Seagate Technology Tel: 405-324-3070
10323 West Reno (West Dock) Fax: 405-324-3794
Oklahoma City, OK 73127-9705 gene_milligan@notes.seagate.com
P.O. Box 12313
Oklahoma City, OK 73157-2313

8/26/2000

Subject: **Proposal for revision of the timing tables and definitions in SPI-4**

Application of timing budget - skew block diagram with pre-compensation

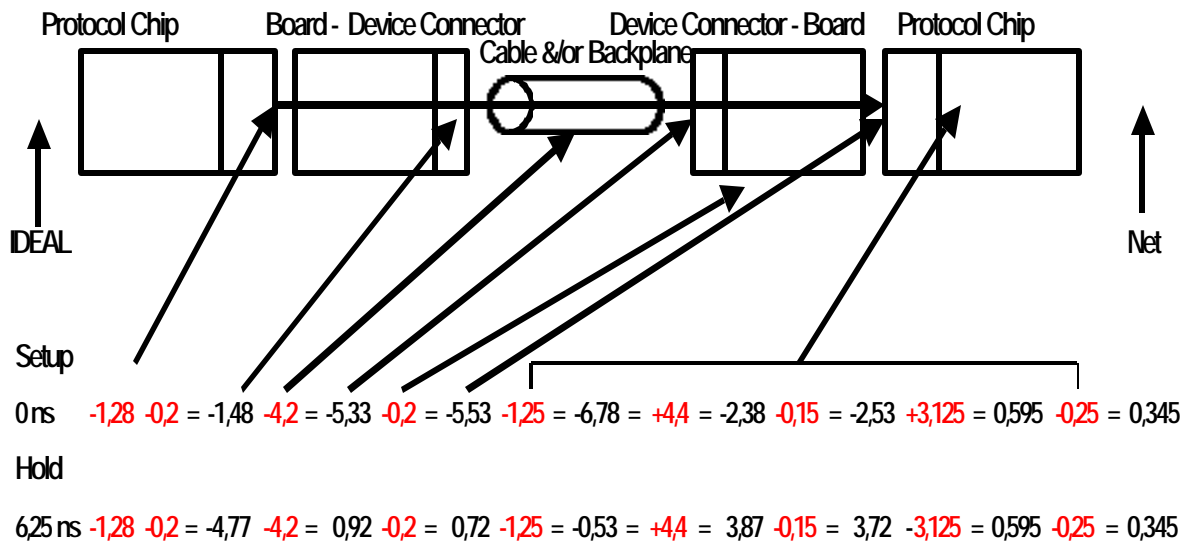
1) The transmitting SCSI device may reduce or increase the timing margin by the following worst case factors: bit period tolerance (i.e., REQ(ACK) Period Tolerance / 2); driver asymmetry; clock jitter; system noise at launch; pre-compensation; and board skew.

2) The transmission of data from one SCSI device to another may have the timing margin reduced by the signal timing skew that comprises the following worst case factors; crosstalk; cable skew; and ISI. If precompensation is invoked the worst case signal timing skew is reduced by the ISI compensation value. Portions of the crosstalk and ISI may also be observable at the transmitting device connector. Consequently transmit setup and transmit hold time should be measured with an alternating pattern at the negotiated data rate with all data signals other than that being measured held at a continual assertion or negation.

3) The reception of data within a SCSI device may have the timing margin reduced or increased by the following additional worst case factors: board skew; receiver amplitude time skew; receiver chip skew; receiver time asymmetry; system noise at the receiver; receiver chip noise (applied at receiver due to small signal physics); ISI compensation; skew compensation; strobe offset tolerance; and residual skew error.

Application of timing budget - skew block diagram with post-compensation

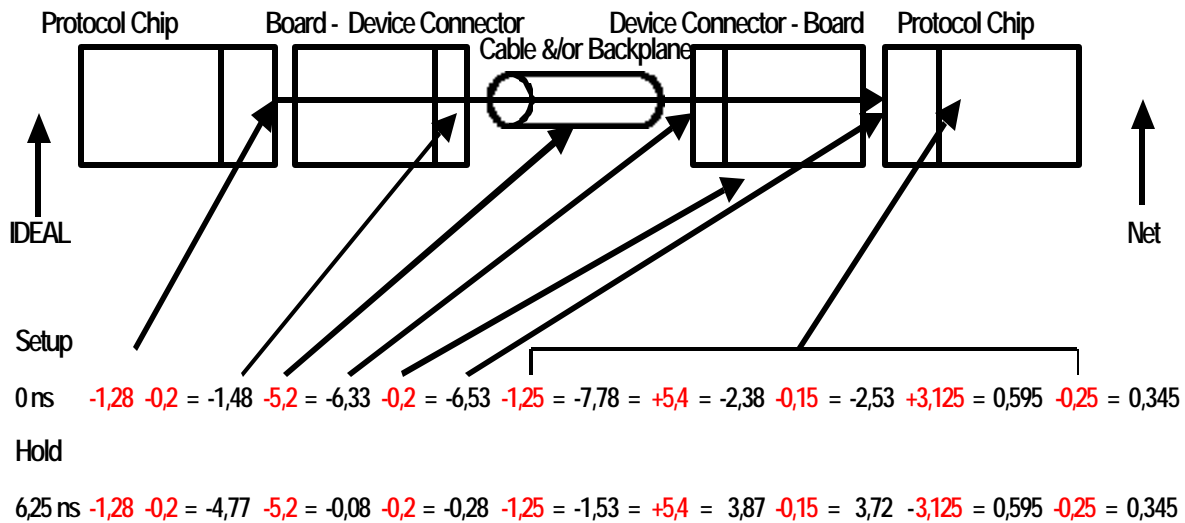
1) The transmitting SCSI device may reduce the timing margin by the following worse case factors: bit period tolerance (i.e., REQ(ACK) Period Tolerance / 2); driver asymmetry; clock jitter; system noise at launch; and board skew.

2) The transmission of data from one SCSI device to another may have the timing margin reduced by the signal timing skew that comprises the following worse case factors; crosstalk; cable skew; and ISI. If precompensation is invoked the worse case signal timing skew is reduced by the ISI compensation value. Portions of the crosstalk and ISI may also be observable at the transmitting device connector. Consequently transmit setup and transmit hold time should be measured with an alternating pattern at the negotiated data rate with all data signals other than that being measured held at a continual assertion or negation.

3) The reception of data within a SCSI device may have the timing margin reduced or increased by the following additional worse case factors: board skew; receiver amplitude time skew; receiver chip skew; receiver time asymmetry; system noise at the receiver; receiver chip noise (applied at receiver due to small signal physics); ISI compensation; skew compensation; strobe offset tolerance; and residual skew error.
